QUALITY ASSURANCE -- NON-CONFORMANCE REPORT

Report No: NCR-000965

Reference Description: Unspecified welding of Tower Walkway Support Beam to Sea Fastener

Job Name: SAS Superstructure
Document No: 05.03.06-000922

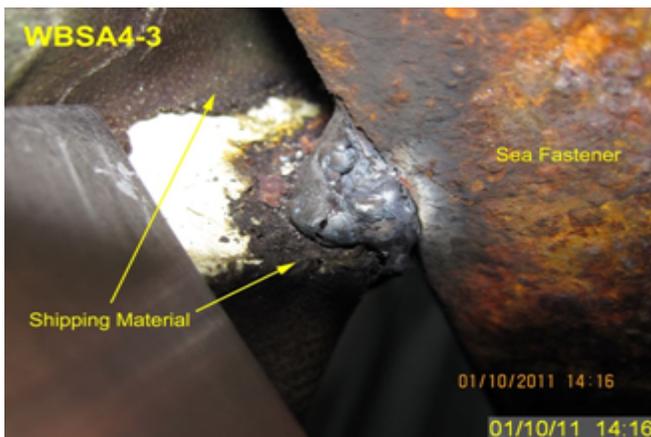
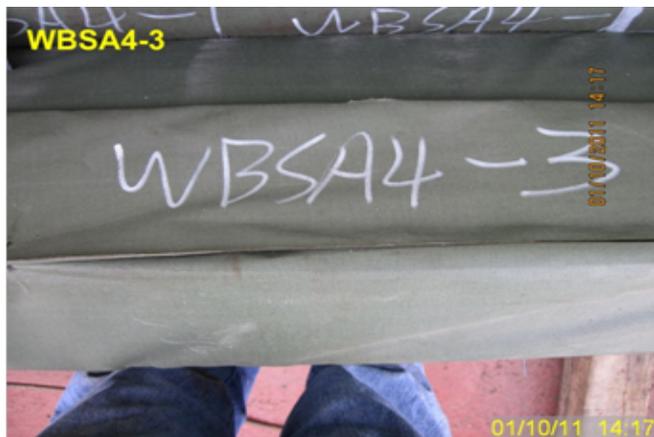
During the Quality Assurance (QA) random visual inspection of Tower Components being loaded on Ship (Zhen Hua vessel #18), this QA Inspector discovered the following issues:

- ZPMC has welded a ship sea fastener to a Walkway Support Beam.
- The approved shop drawings do not specify any welds in these areas.
- The member is identified as WBSA4-3.
- The additional material and welding was not approved by the engineer
- This QA also noted that ZPMC did not appear to have preheated the area welded.
- It appears that ZPMC personnel welded through the shipping material.

Reference Resolution: "ZPMC has removed the tack weld and repaired the surface by grinding and re applied the paint under the supervision of the Department's representative which was acceptable.

"ZPMC has removed the tack weld and repaired the surface by grinding and re applied the paint under the supervision of the Department's representative which was acceptable. In the future to prevent these incidents more supervision of workers on the boat will be provided by ZPMC's QC Department and the department responsible for loading."

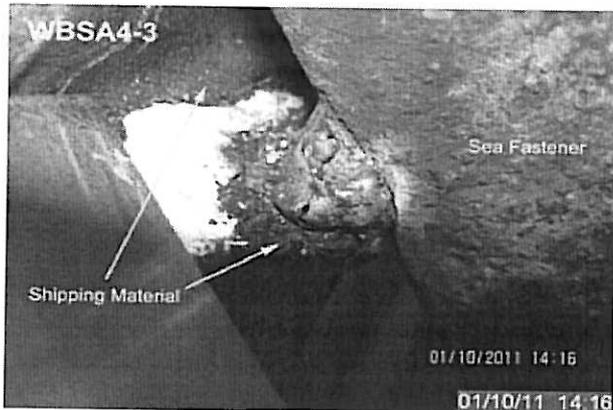
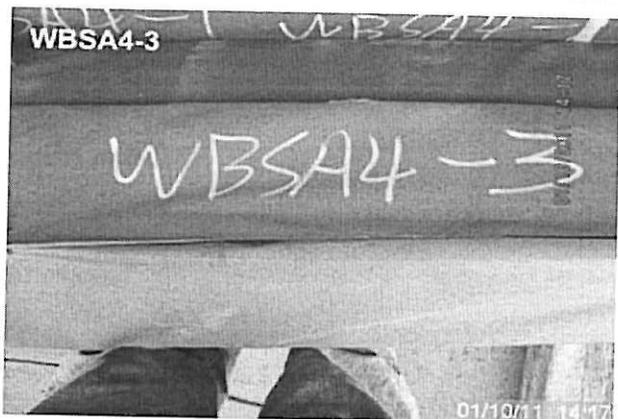
During the Quality Assurance (QA) random visual inspection of Tower Components being loaded on Ship (Zhen Hua vessel #18), this QA Inspector discovered the following issues:

- ZPMC has welded a ship sea fastener to a Walkway Support Beam.
- The approved shop drawings do not specify any welds in these areas.
- The member is identified as WBSA4-3.
- The additional material and welding was not approved by the engineer
- This QA also noted that ZPMC did not appear to have preheated the area welded.
- It appears that ZPMC personnel welded through the shipping material.

Reference Resolution: ZPMC is providing the MT report after the tack weld was removed to show the base metal is acceptable after grinding, and the paint applied was acceptable.

ZPMC is providing the MT report after the tack weld was removed to show the base metal is acceptable after grinding, and the paint applied was acceptable. Supervision of the loading was increased to prevent other incidents from occurring during loading. Based on this, ZPMC requests closure of this NCR.

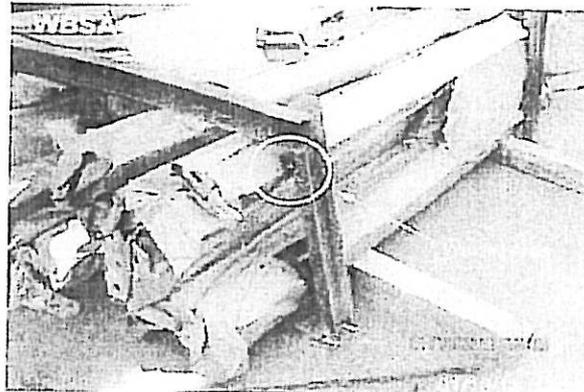
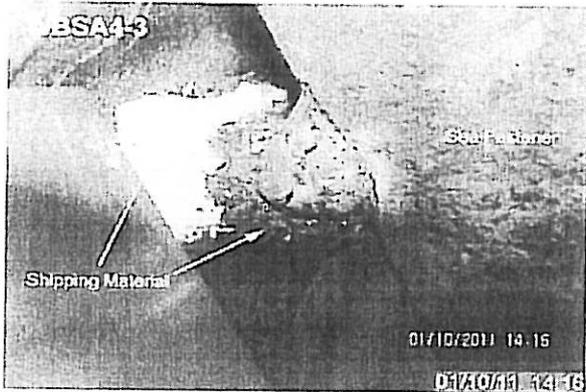
During the Quality Assurance (QA) random visual inspection of Tower Components being loaded on Ship (Zhen Hua vessel #18), this QA Inspector discovered the following issues:

- ZPMC has welded a ship sea fastener to a Walkway Support Beam.
- The approved shop drawings do not specify any welds in these areas.
- The member is identified as WBSA4-3.
- The additional material and welding was not approved by the engineer
- This QA also noted that ZPMC did not appear to have preheated the area welded.
- It appears that ZPMC personnel welded through the shipping material.

Contractor will remove the tack weld between sea fasteners to Walkway Support Beams. MT report will be provided to prove the base metal is acceptable. Contractor will inspect paint repaired areas. The loading supervision will increase to prevent the future incidents.

Contractor removed the tack welds between sea fasteners to Walkway beams and ground flush. MT was performed with acceptable MT results. Paint repairs were performed in accordance with the approved PQWP and are acceptable.
